Comments - Environmental Permit Review Maine Department of Inland Fisheries and Wildlife

Inland Fisheries and Wildlife Division Comments Bureau of Resource Management Comments – Regions G, F

Applicant's Name: Number Nine Wind Farm, LLC	
Project #: L-26502-2F-G-N; -24-H-N; -IW-I-N; -L6-J-N; -VP-K-N; -TH-L-N.	Regulatory Agency: MDEP
Project Type: Windpower Facility	Project Manager: Jessica Damon
Comments Due Date:	Date Comments Sent: 11-16-2015
Project Location	
Towns: T10 R3 WELS; E Township; T9 R3 WELS; TD R2 WELS; T8 R3 WELS; Saint Croix Township	County: Aroostook
Waterbodies: Meduxnekeag River watershed; Prestile Stream watershed; St. Croix Stream watershed; Mattawamkeag River watershed	
Biologists (review coordinators): John Perry, Bob Stratton	
Biologists (Fisheries Division): Frank Frost, Jeremiah Wood, Nels Kramer, Kevin Dunham	
Biologists (Wildlife Division): Danielle D'Auria, Erynn Call, Mark Caron, Amanda DeMusz, Shawn Haskell, Rich Hoppe, Cory Mosby, Allen Starr, Beth Swartz, Charlie Todd

Figure 1. Large DWA complex in northwest section of project

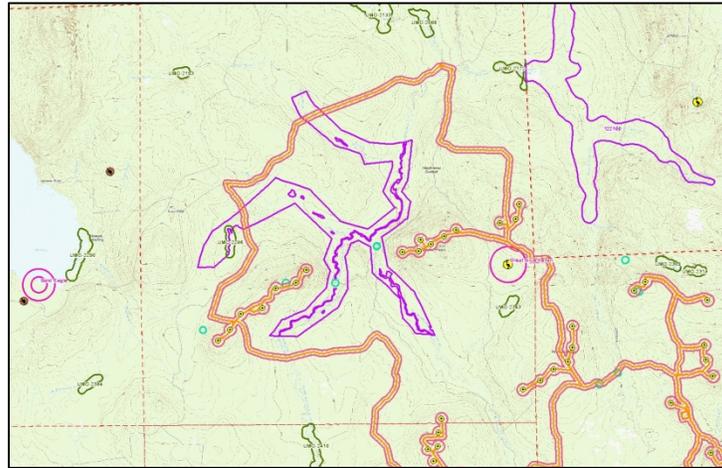
While we appreciate the efforts that the Applicant went through to relocate the proposed crane access road that would have diminished functionality in portions of the DWA complex in the northwest section of the Project area, we continue to have concerns with indirect impacts from turbine strings DD (7 turbines) and M (8 turbines) to the large DWA complex (Figure 1 below). Turbine String M is the same string which also puts active heron colony WBC0823 at risk. Specifically, we have concerns with indirect impacts from turbine strings DD (7 turbines) and M (8 turbines) to the large DWA complex in the northwest section of the Project area (Figure 1 below). Specifically, we have concerns what indirect impacts will be realized with a series of two turbine strings, totaling 15 turbines, will have on wintering deer. This Agency is aware of research and anecdotal information regarding noise impacts on wildlife, but to our knowledge there is no published research specific to effects of wind farms on deer, and specifically overwintering deer. While we acknowledge that deer do become accustomed to some types of anthropogenic noises such as heavy traffic, we do not have data on effects of the continuous low-frequency noise and vibrations may have on deer attempting to overwinter in these areas. However, we are aware of general wildlife displacement research associated with operating wind farms, and we have literature regarding low frequency infrasound and there appears to be cause for concern. Given the productivity of this DWA and the value assigned to DWAs in general in this part of Maine, MDIFW recommends that turbine strings DD and M be removed or relocated away from the DWA, if a modified project design were to be considered.

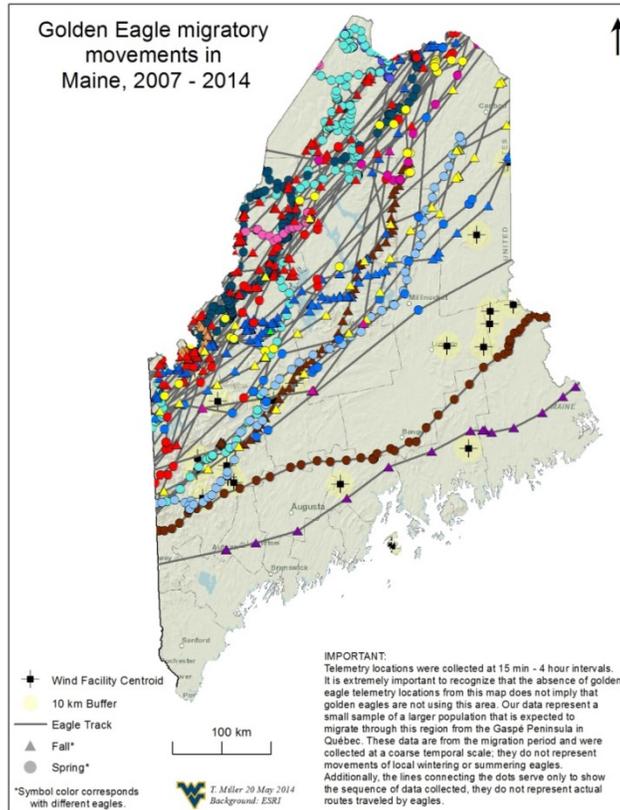
As proposed, our Agency understands that there will be impacts to Significant Vernal Pools and their critical terrestrial habitats as a result of this Project. Staff have reviewed over 350 vernal pool forms for the Project area and is currently awaiting additional information and clarification from the Applicant. Therefore, we are not able to provide informed recommendations on impacts to Significant Vernal Pools at this time.
